MONUMENT TOWN COUNCIL REGULAR MEETING AGENDA

SUBJECT: Ordinance No. 05-2025, An Ordinance Granting Approval of a Final Planned Unit Development for Jackson Creek North Retail at Monument Market Place North Lot 2 [Public Hearing]

SUBJECT: Case No. 007-2024 FPD
Final Planned Unit Development for Jackson Creek Retail, legally described as
Lot 2, Monument Marketplace North Filing No. 1A and located at 16577
Cinematic View [Public Hearing]

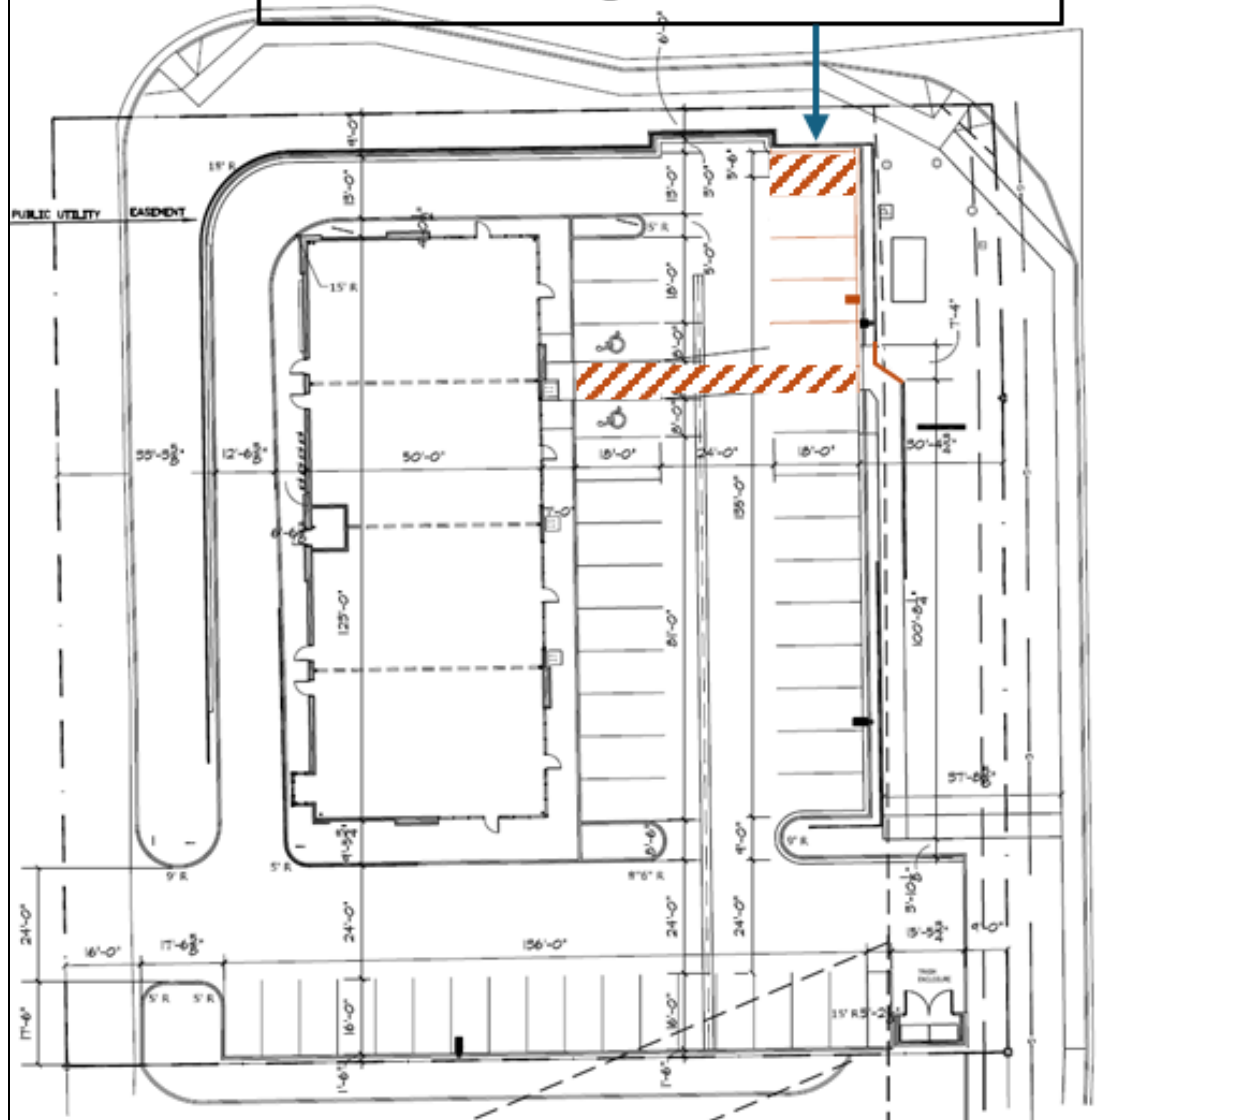
No Parking area (reserved for turnaround), shall be included. Pedestrian crossing located in parking lot shall be reduced in width to create adequate space for the “No Parking Area”.

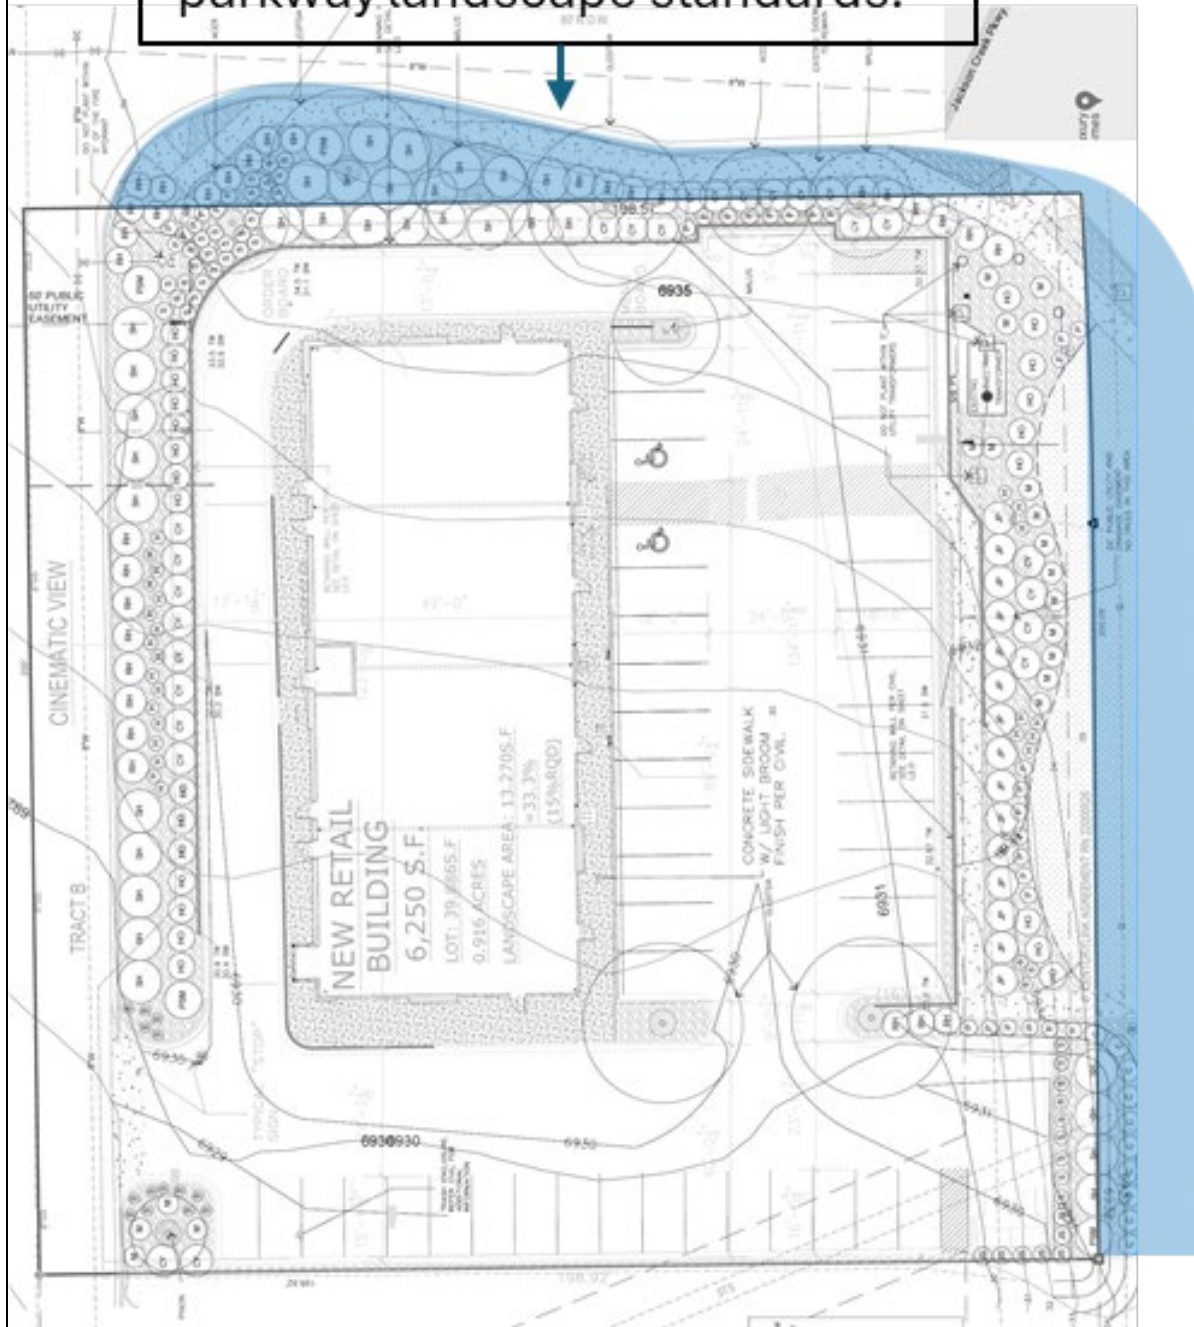
This area is public right-of-way.
Revise plant materials per Town
parkway landscape standards.
